CITY OF MERCER ISLAND

September 14, 2021

RE: Request for Information #1 for File No. SUB21-002 – Angiuli Pacific Res Trust Short Subdivision
4001 West Mercer Way, Mercer Island, WA 98040; King County Tax Parcel # 362350-0365

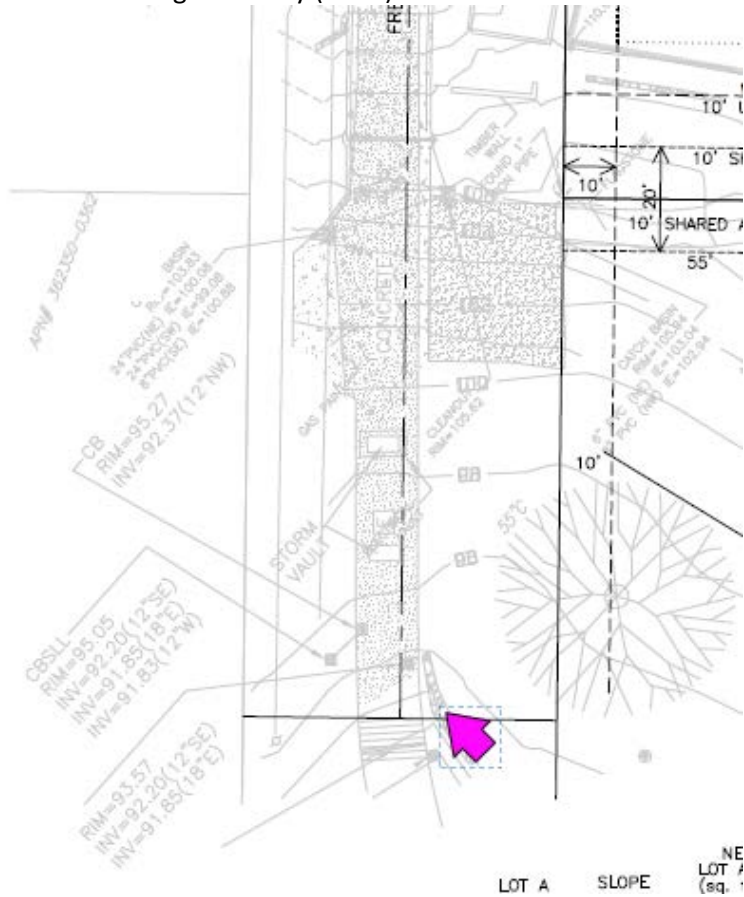
- d. Topographic map: for any existing buildings, the map shall show the finished floor elevations of each floor of the building.
 - e. Please note lot area and net lot area. Net lot area is the area contained within the established boundaries of a lot, less any area used for public or private vehicular access easements, excluding that portion of the easement used for a driveway access to the encumbered lot. The minimum **net lot area** for the R-15 zone is 15,000 square feet. For Lot A, the portion of the access easement used to access the future house on Lot A can be a maximum of 342sf since the current proposed lot area for Lot A is 15,342sf. When measuring the proposed shared access easement area on Lot A using the provided scale it came out to ~885sf.

- f. Illustrate the proposed driveway and building footprint location on Lot A. The proposed driveway location will impact the net lot area.

Here is the design. Figure 8.

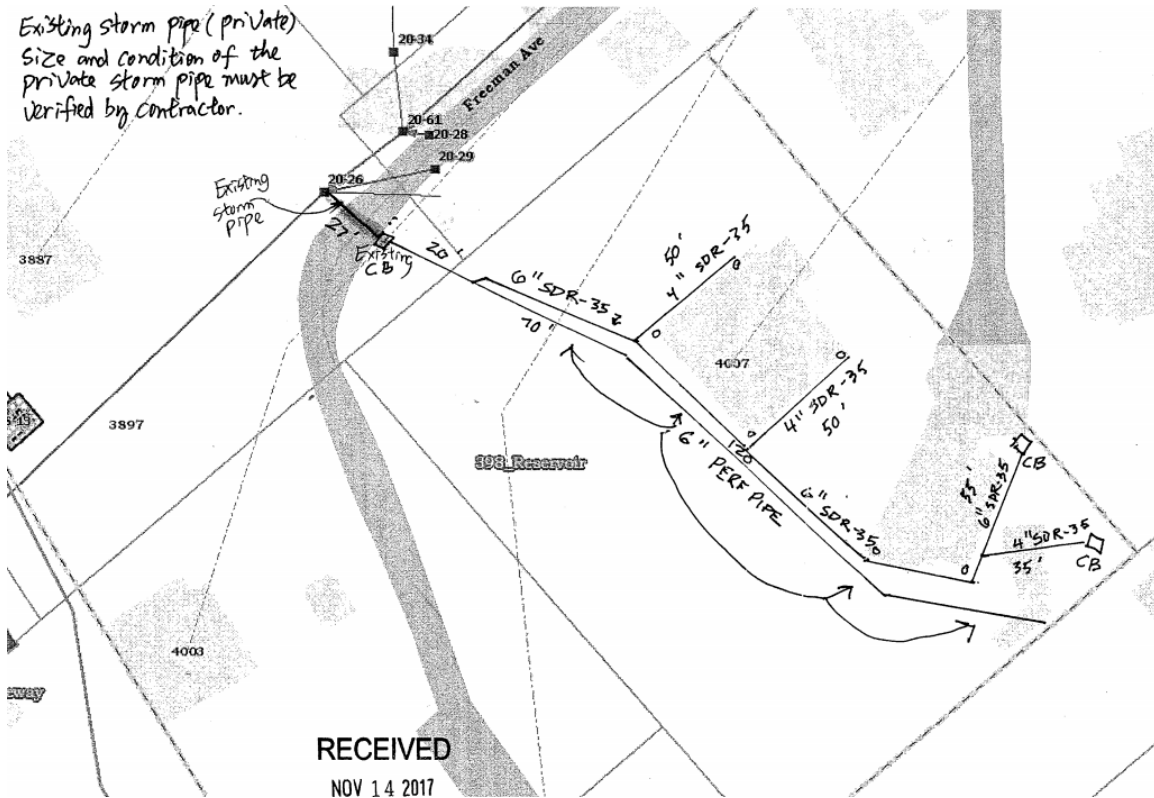
As I reviewed the diagram, I wondered why the drainage was so far East of the hillside, as far as 30' away in parts.
